# URBAN DESIGN COMMITTEE

2. [9<sup>th</sup> and R Redevelopment](#) – [UDR23075](#)

## URBAN DESIGN COMMITTEE STAFF REPORT

APPLICATION NUMBER	Urban Design Record #23075
APPLICATION TYPE	Advisory Review
ADDRESS/LOCATION	401 N 9 <sup>th</sup> Street
HEARING DATE	July 11, 2023
ADDITIONAL MEETINGS	October 4, 2022 (original review by UDC) and June 6, 2023 (review of the canopy modification by UDC)
APPLICANT	Hallie Salem, 402-441-7866, hsalem@lincoln.ne.gov
STAFF CONTACT	Collin Christopher, 402-441-6370, cchristopher@lincoln.ne.gov

## ATTACHMENT B – Original Canopy Rendering

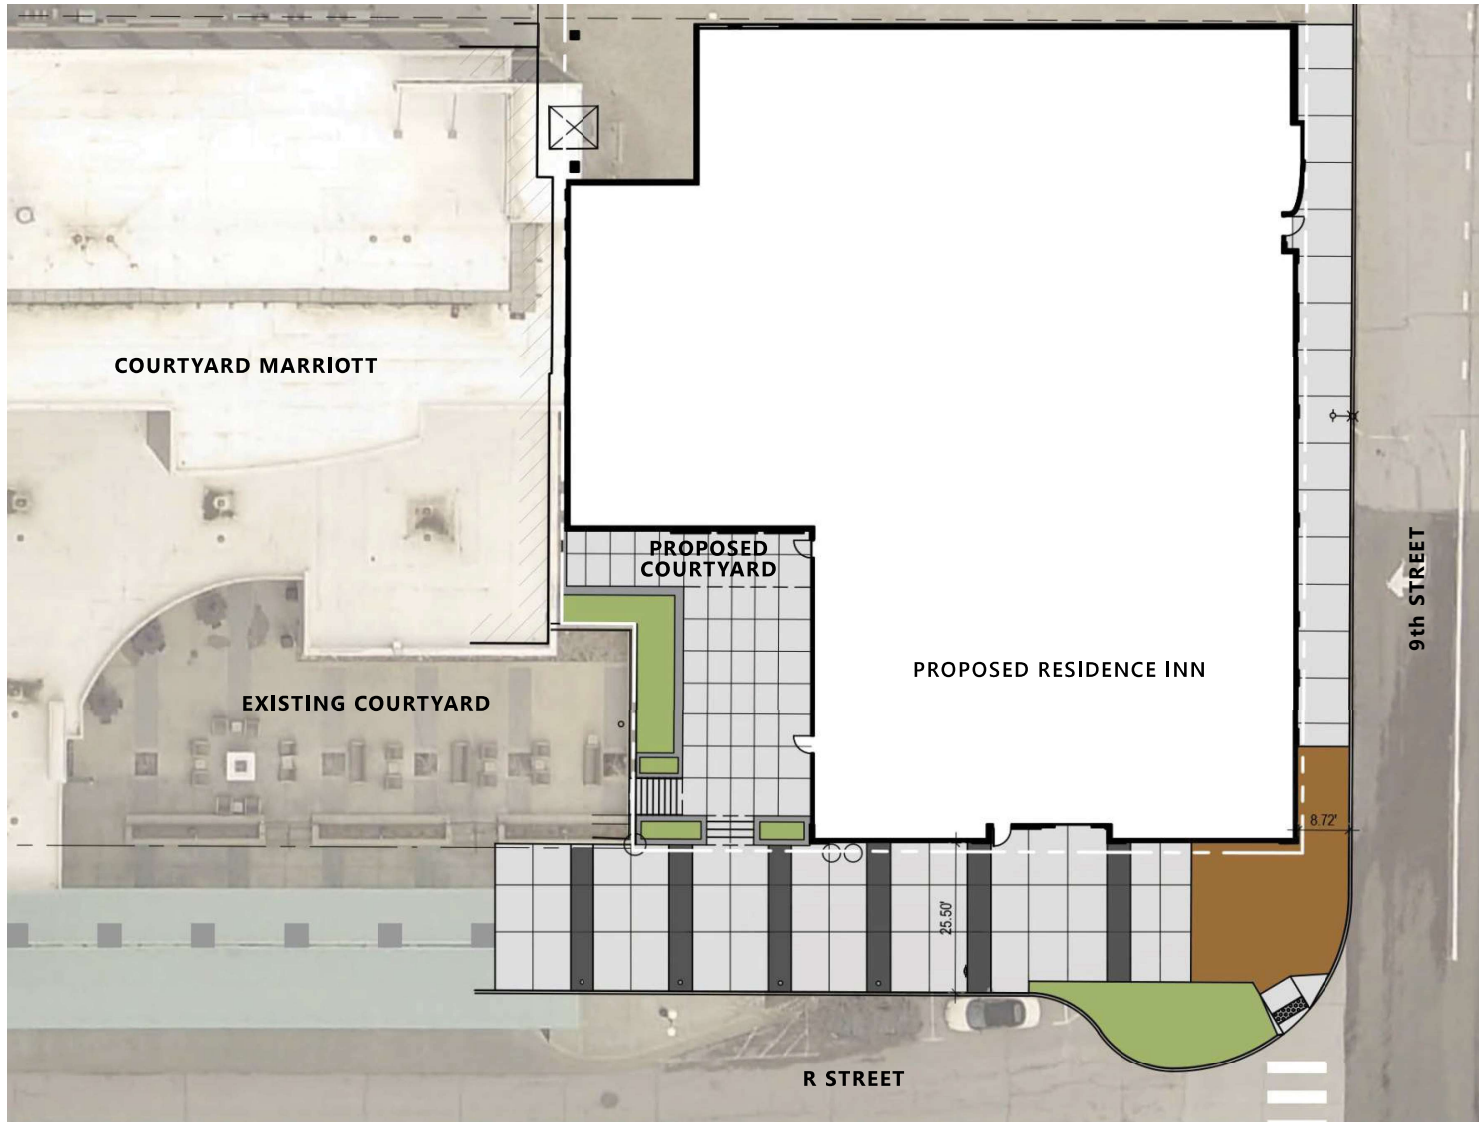
As can be seen in the attached renderings, the original proposal included a freestanding canopy south of the building that would complement the existing canopy in front of the adjacent Courtyard by Marriott. What is now being shown is an enlarged canopy extending out from the building's south façade. The canopy would consist of white, metal panel soffits with aluminum batten linear soffit slats above the lobby entry point.
